Woollahra Local Planning Panel (Electronic Meeting)

845 New South Head Road, Rose Bay

Woollahra Local Planning Panel (Electronic Meeting) – 27 February 2024
DA 290/2023/1 - 845 New South Head Road Rose Bay

LOCAL PLANNING PANEL DEVELOPMENT APPLICATION ASSESSMENT REPORT

10.5m HEIGHT PLANE DIAGRAM

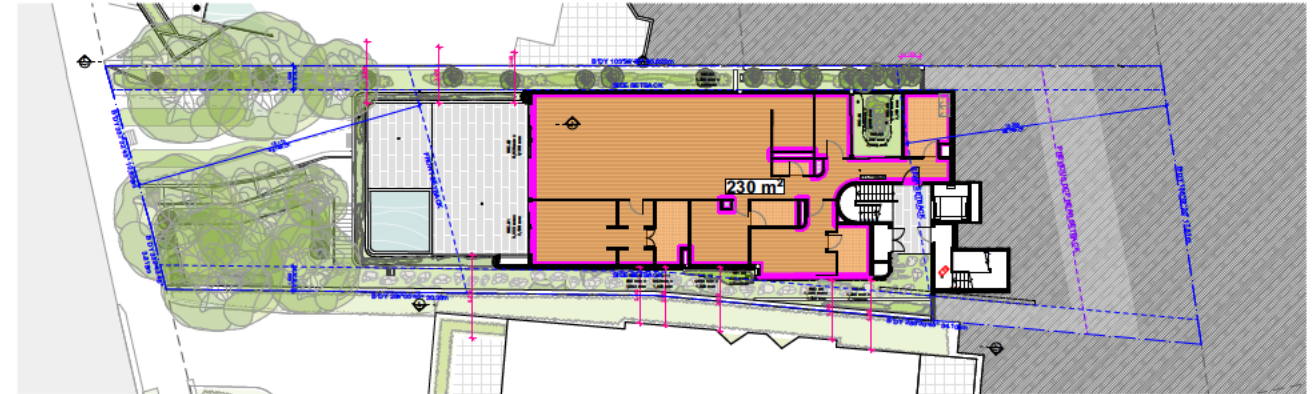
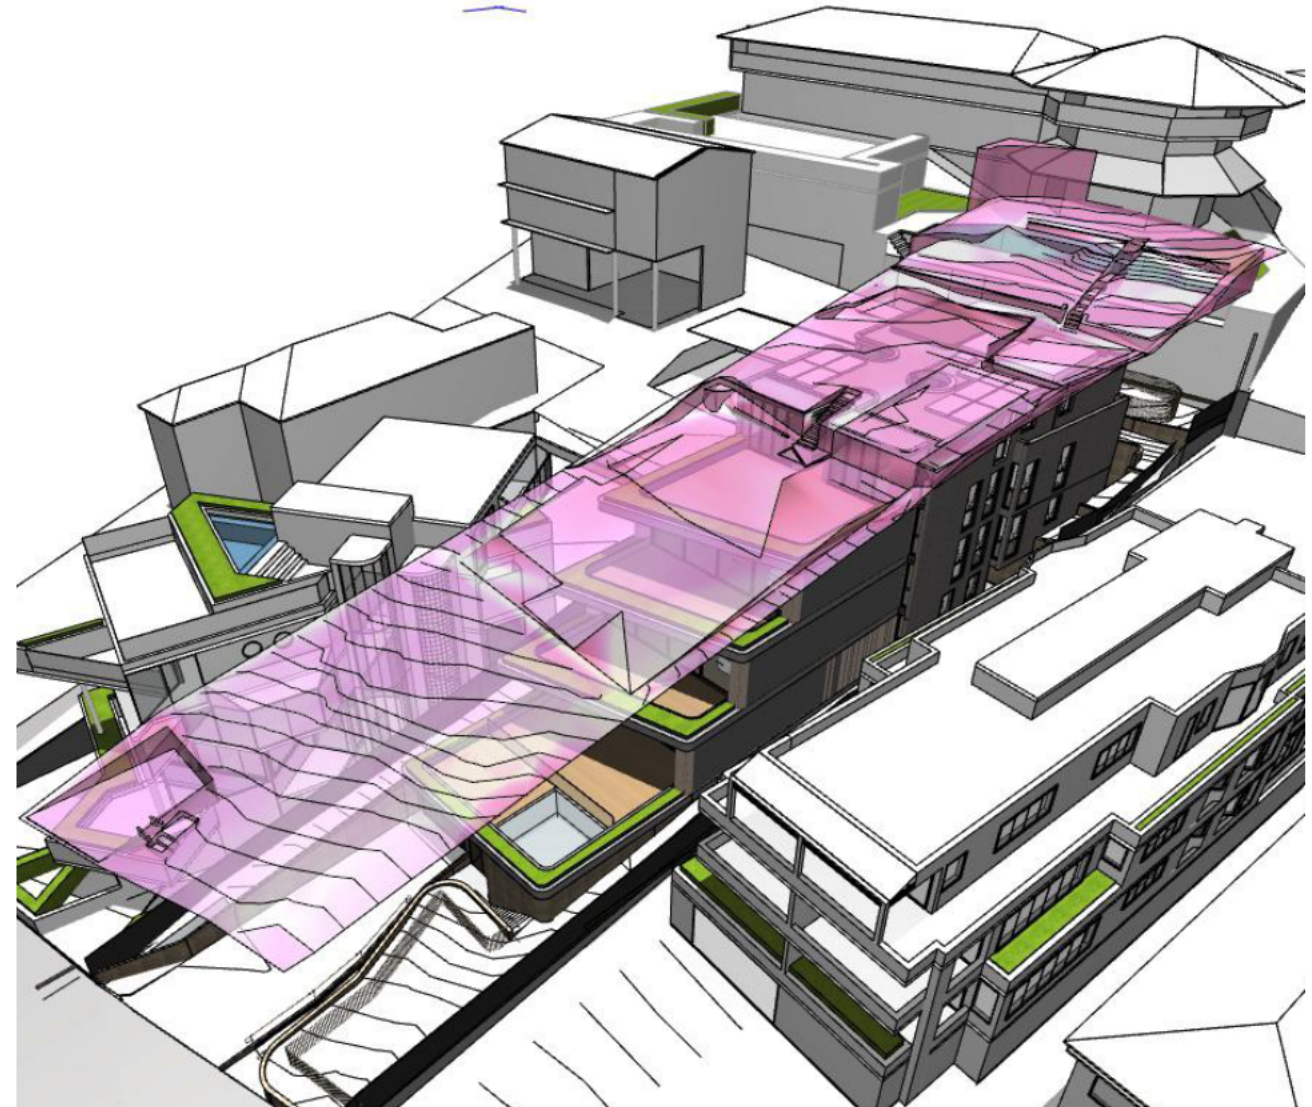
Architectural drawing No. DA3101 prepared by MHN Design Union Pty Ltd illustrates a section plan that depicts the 10.5m height plane in associated with the existing ground line. A section of the parapet/roof form appears to fall outside the 10.5m height maximum. Insufficient information is provided to confirm or otherwise the height of the development. Additional sections are required to be provided with adequate level of information clearly indicated depicting the maximum overall height of the proposed development in relation to the existing ground level below that point in order to confirm compliance with Clause 4.3 of the Woollahra LEP 2014.

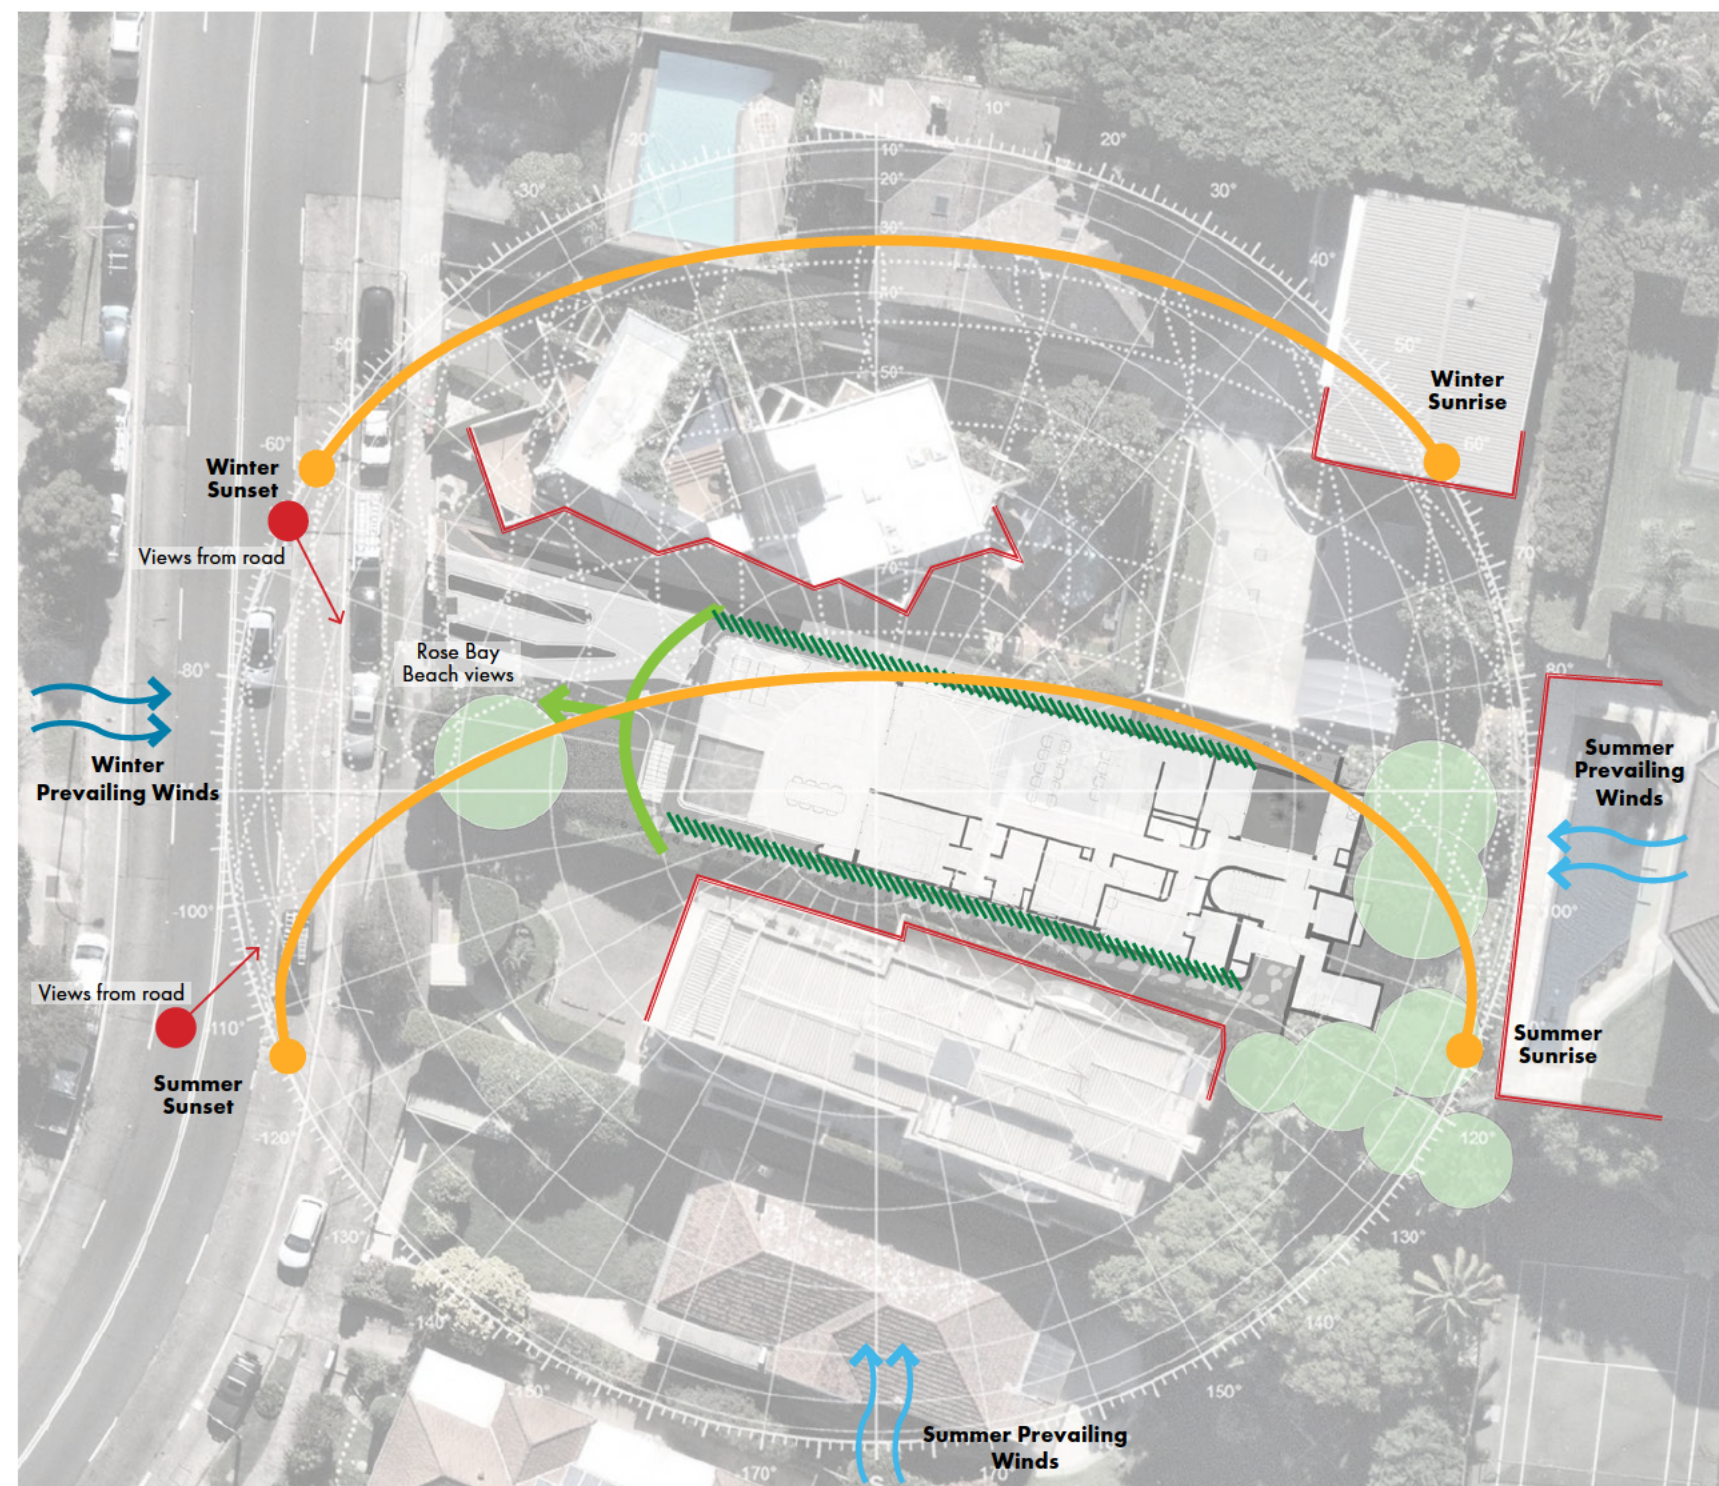
- a) The existing *Callistemon* tree located at the rear northern boundary of 843 New South Head Road must be accurately plotted and referenced as Tree 12 on the submitted plans and within Figure 5 of the submitted Botanics tree report.

- d) The submitted survey plan and all architectural plans must reference and accurately plot all existing trees located within the property and at 843 New South Head Road in accordance with Figure 5 of the Botanics arboricultural report.

Several of the amended architectural drawings now reference existing trees located at 843 New South Head Road, including Tree 12. However, an amended survey plan has not been submitted that accurately plots and references existing trees located within the property and at 843 New South Head Road in accordance with Figure 5 of the Botanics arboricultural report and the updated architectural drawings.
